Design & Access & Heritage Response

RE: 15-17 Macklin Street, London, WC2B 5NG

Existing casement window detail

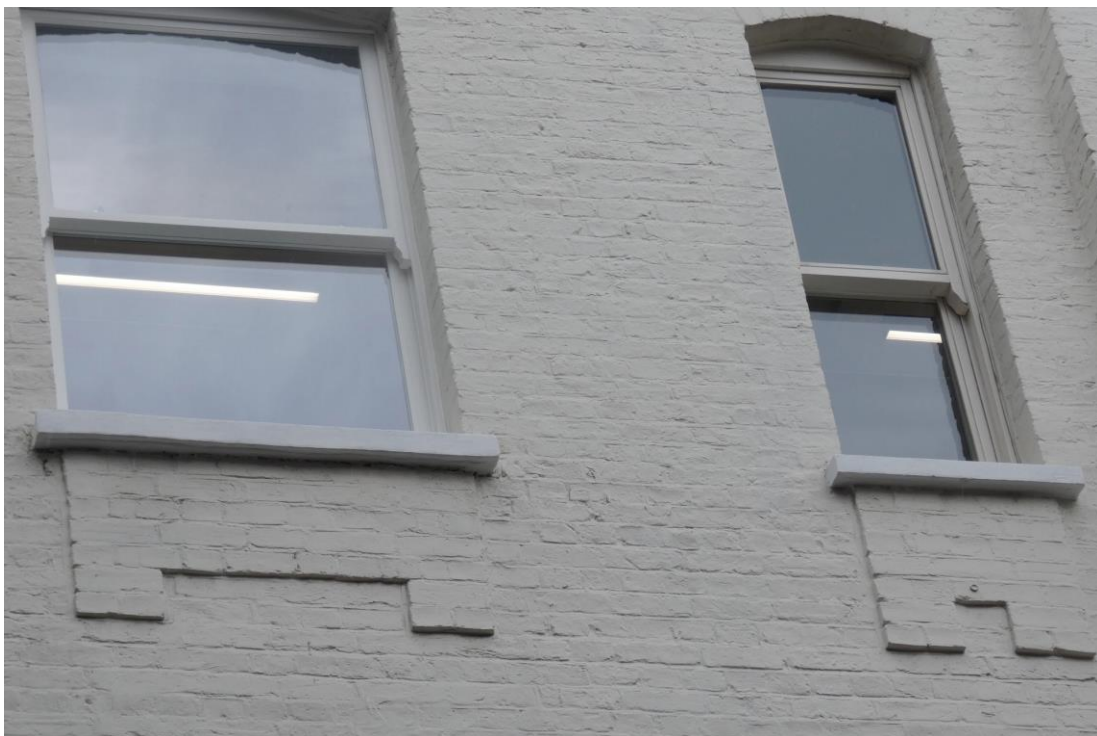
I will have to object for this application for now for the Seven Dials CAAC until a D&A statement is submitted. Given the status of this building within the CA the application details are completely inadequate. Specifically we need to know if the existing windows are historic, why they are being replaced, etc.

10. The following photos of existing windows that are retained show that they were previous factory-made replacements and not original, whereas the new custom joinery units are a far better quality, which is shown in the two photos showing an existing and new window side by side (in both instances the new window is on the left and the existing retained on the right).
